**ASHLAND PLANNING COMMISSION
SPECIAL MEETING
MAY 27, 2014
AGENDA**

**ASHLAND PLANNING DIVISION
STAFF REPORT
Addendum
May 27, 2014**

PLANNING ACTION: 2014-00307

LOCATION: 777 Oak Street

A. Description of Revised Proposal

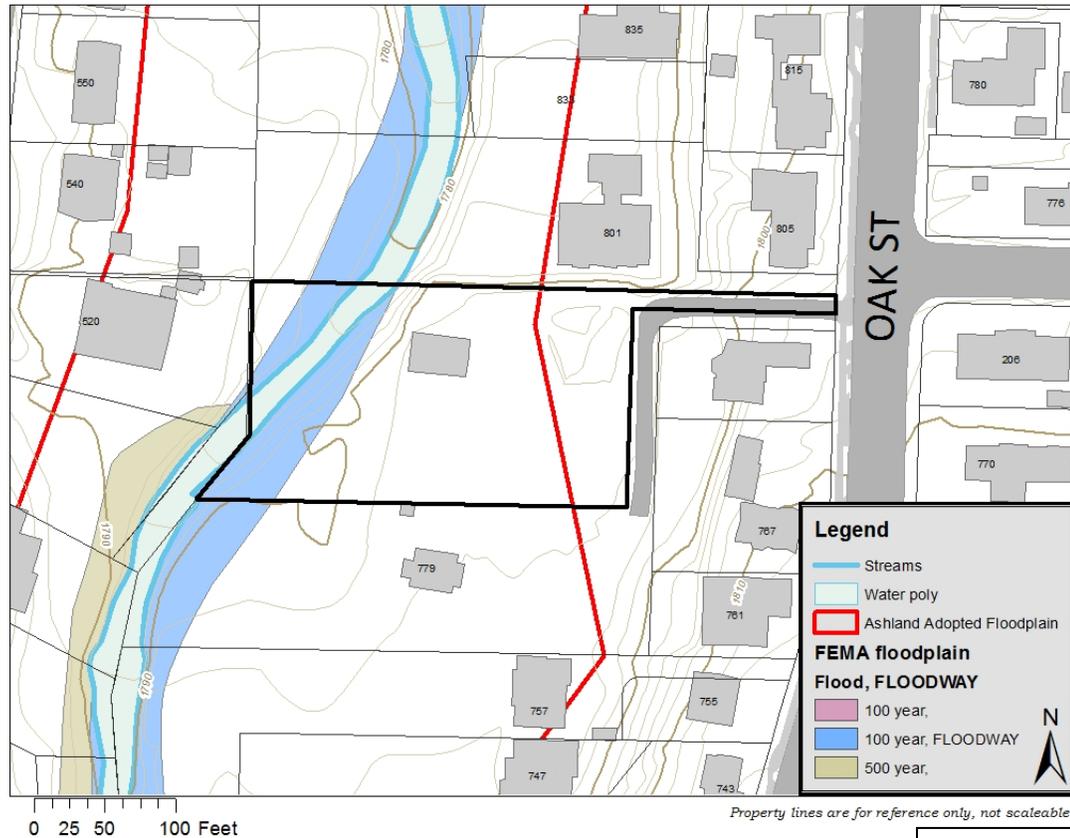
The revised proposal shifts the new primary residence, outdoor areas, garage, and parking to the east, away from Ashland Creek by 15-feet, but the revised location

remains entirely within the Floodplain Corridor. The revised proposal also includes the demolition of the existing 720 square foot vacant single family residence. Finally, the applicant's revised findings state that the change in the proposed home location removes all structures from the Water Resource Protection Zone.

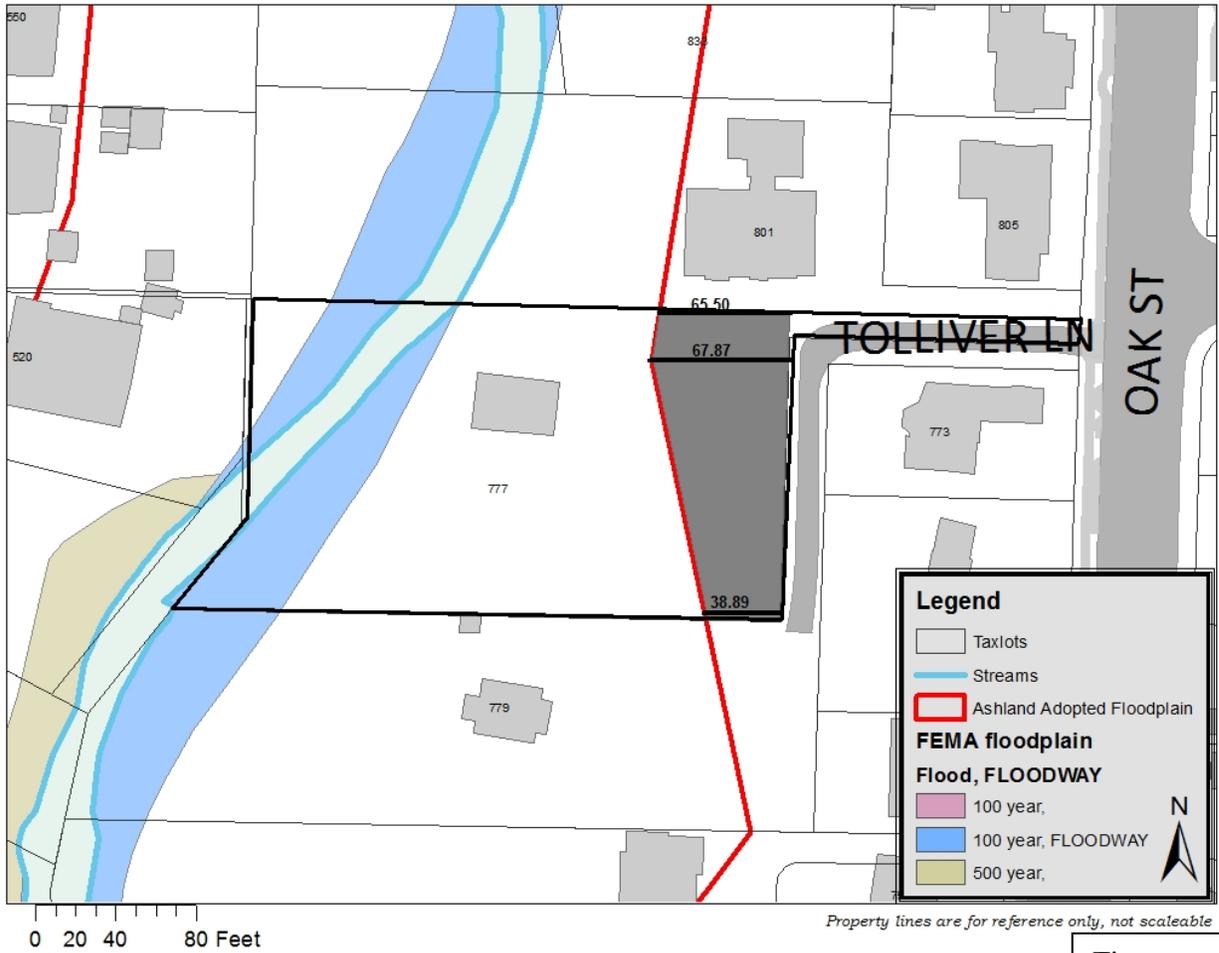
The subject lot includes a buildable area approximately 8,500 square feet in size (grey area on Figure 32) which is outside of the Floodplain Corridor. See Figure 32 on the following page. The revised application does not address why the proposed residence cannot be moved away from the source of flooding. The revised proposal locates the primary residence, garage, parking and outdoor areas entirely within the Floodplain Corridor. The application does not address the criteria from AMC 18.62.070.E.

Decision Point – *Does the application address why the proposed residence cannot be located to the maximum extent feasible on land outside of the Floodplain Corridor, and therefore meet the development standard for floodplain corridor lands in 18.62.070.E?*

Comparative site plan submittals – revised proposal

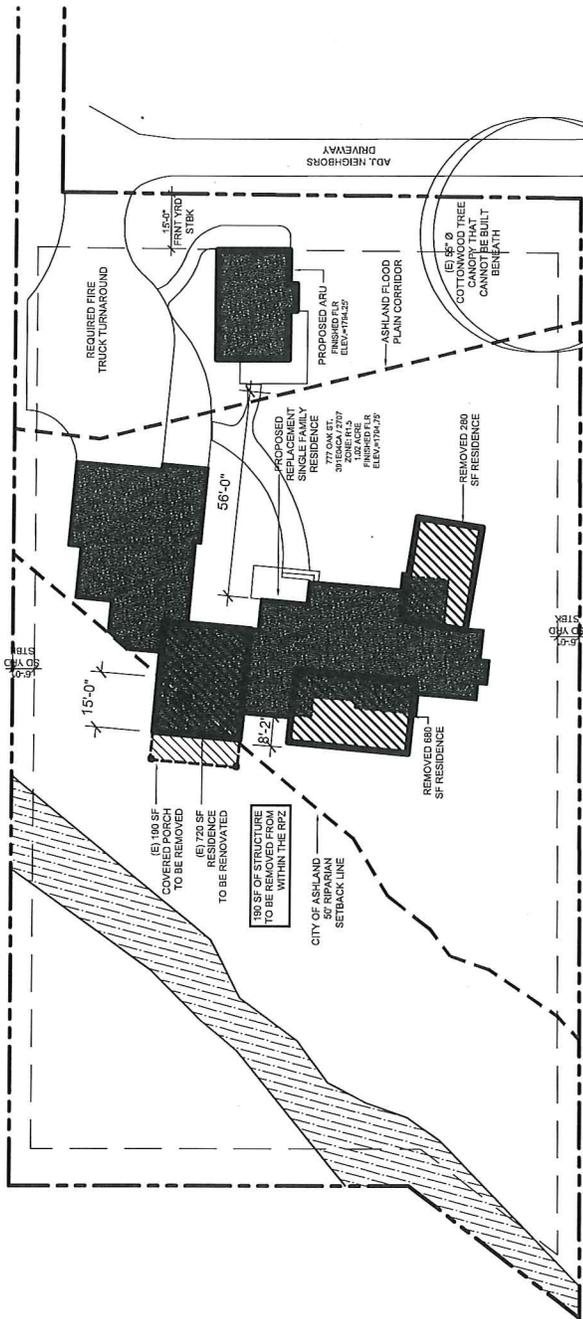
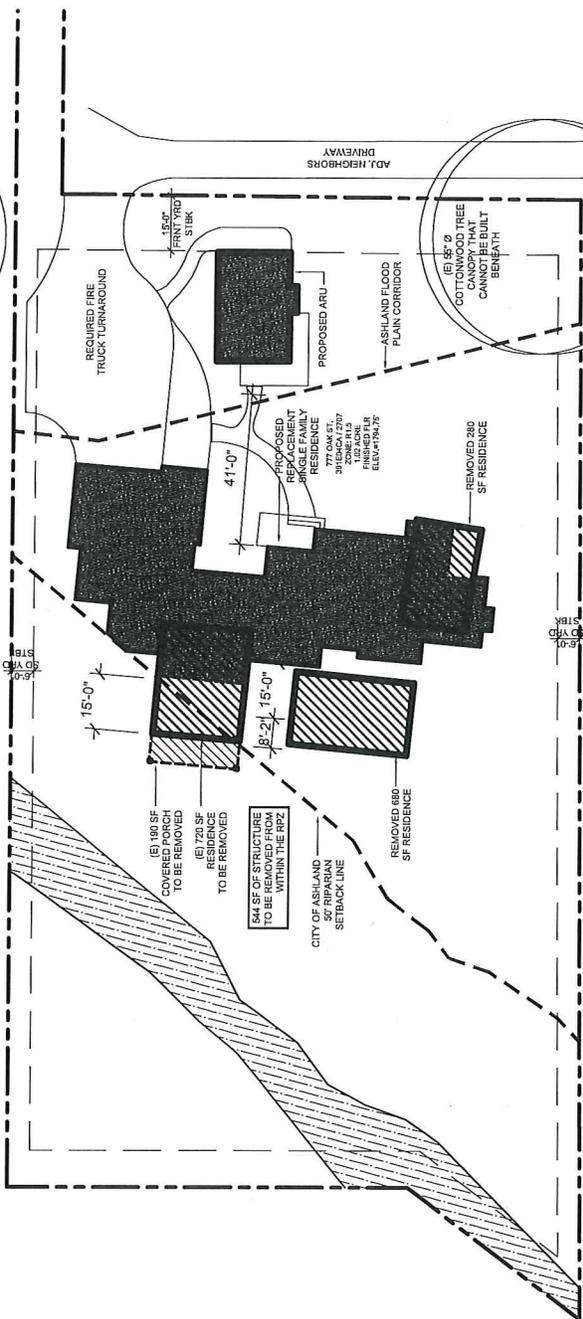
PREVIOUS PROPOSED SITE PLAN

UTILIZING 84.7% OF (E) RESIDENCE EXTERIOR WALL LINES ALLOWABLE THROUGH BLDG CODE

REVISED PROPOSED SITE PLAN

MOVING ALL STRUCTURE TO THE WEST AND SHIFTING THE MAJORITY OF THE PROPOSED RESIDENCE 15' TO THE EAST TOWARD THE FLOOD PLAIN CORRIDOR LINE

GRADING PLAN

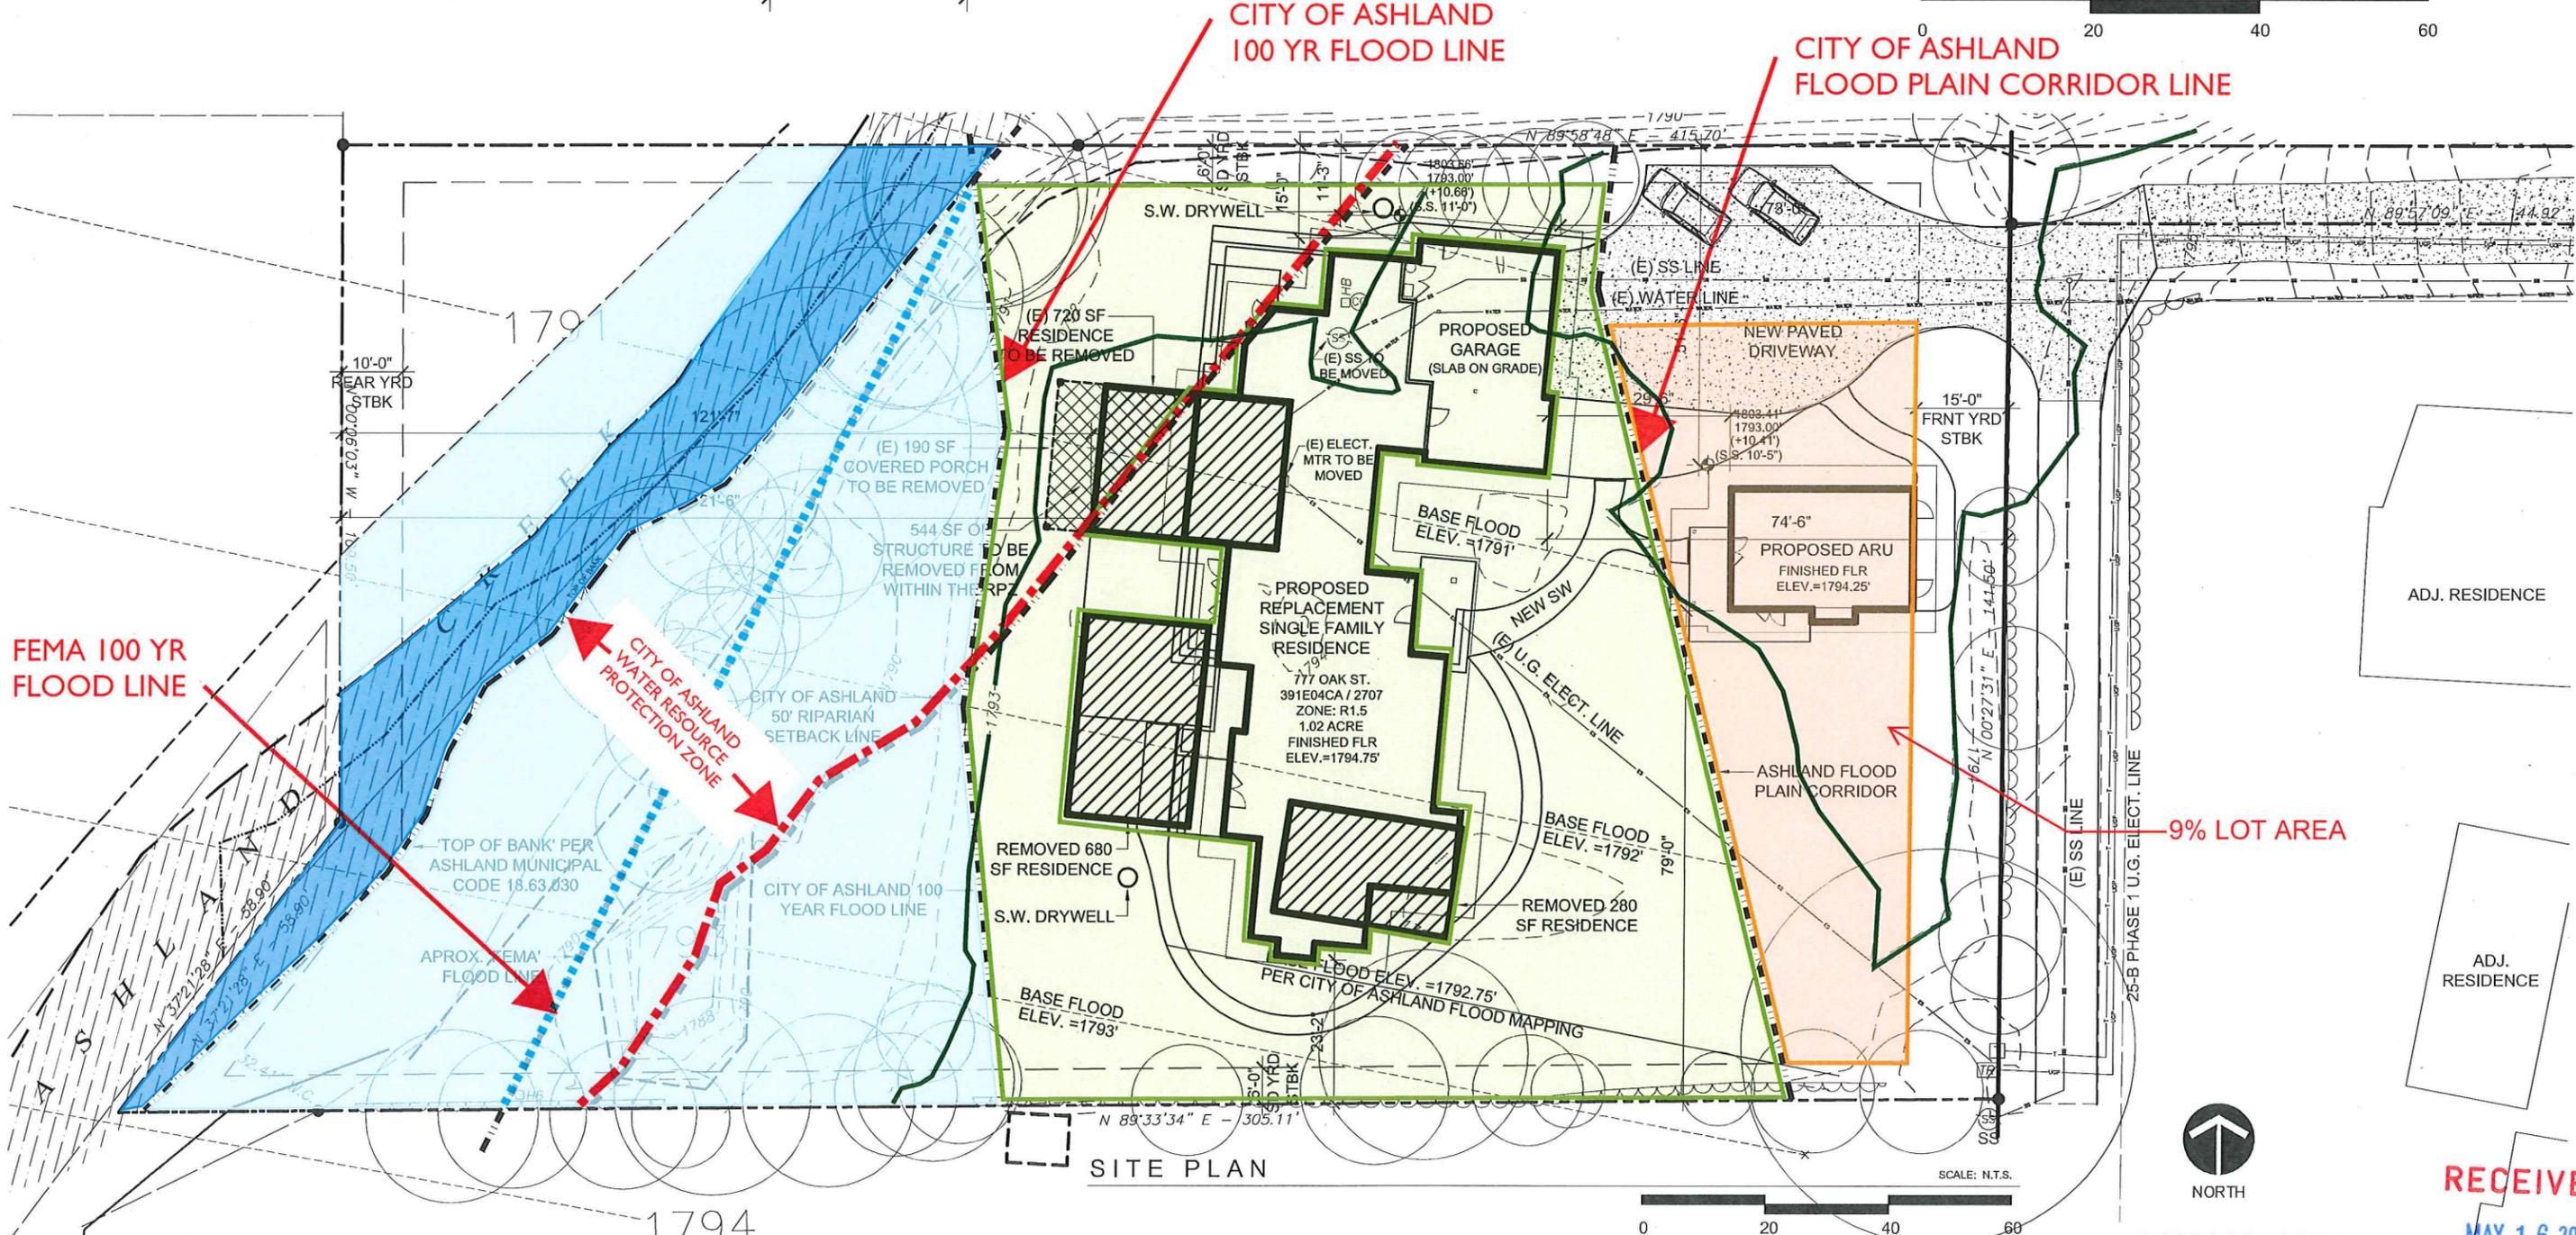
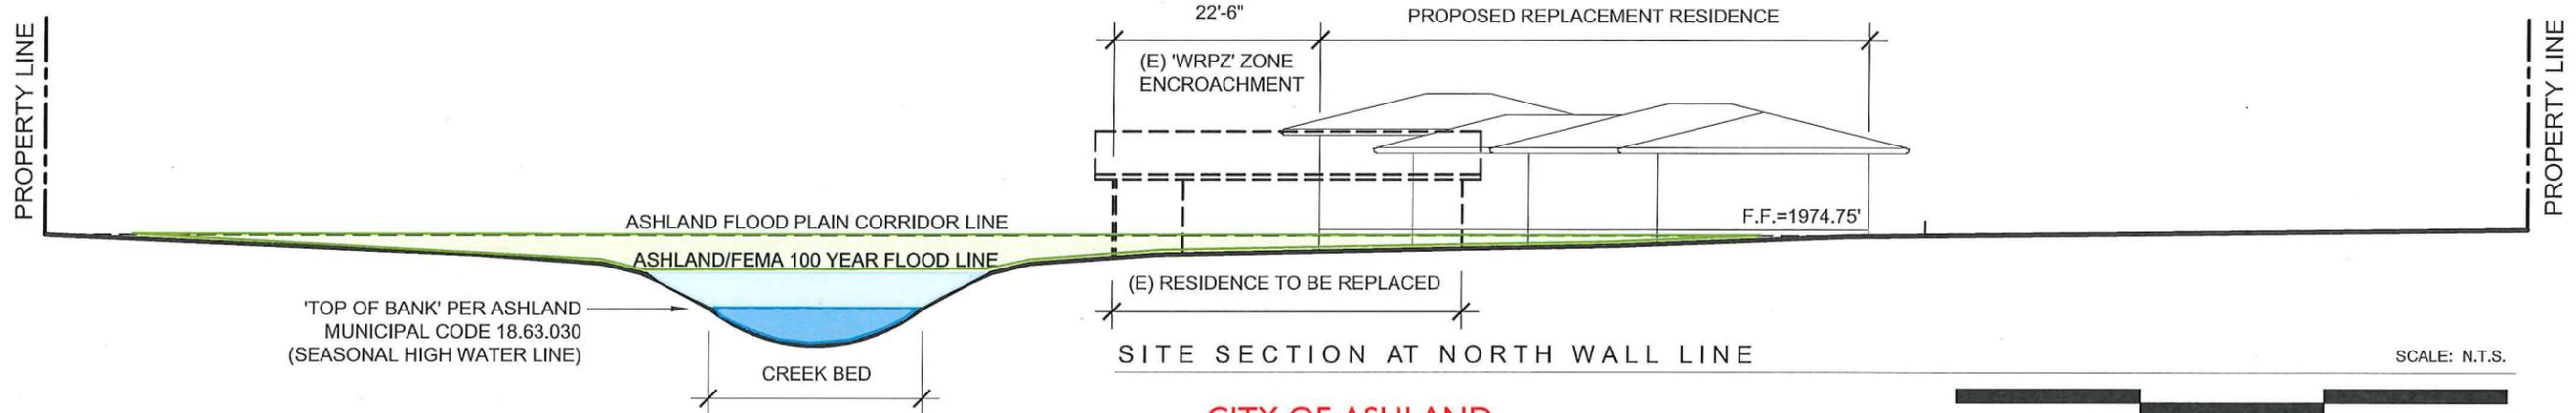
Without details regarding the patio, it is difficult for staff to discern if the standards are met. Based on the elevation of the structure (1794.6) and the elevation of grade (1793.15), there is a low wall and an area noted of up to 12-inches of fill and stairs to get from grade to the patio deck. The patio does not appear to meet the standard because there appears to be fill under the patio area in order to raise it to the height necessary to exist the residence. The presence of fill would indicate that the patio is not a porous solid surface. Additionally, there is a wall around the patio which is not permitted in the WRPZ.

Decision Point – *Does the proposed patio comply with the standard for exemption from the Water Resource Protection Zone ordinance and the definition of a porous solid surface?*

NEW PROPOSAL

- 1) RESIDENCE REPLACEMENT SHIFTED BEYOND WRPZ
- 2) MAJORITY OF RESIDENCE MOVED 15 FEET FURTHER FROM WRPZ BOUNDARY
- 3) ELIMINATE REQUEST TO TO REDUCE WRPZ BOUNDARY
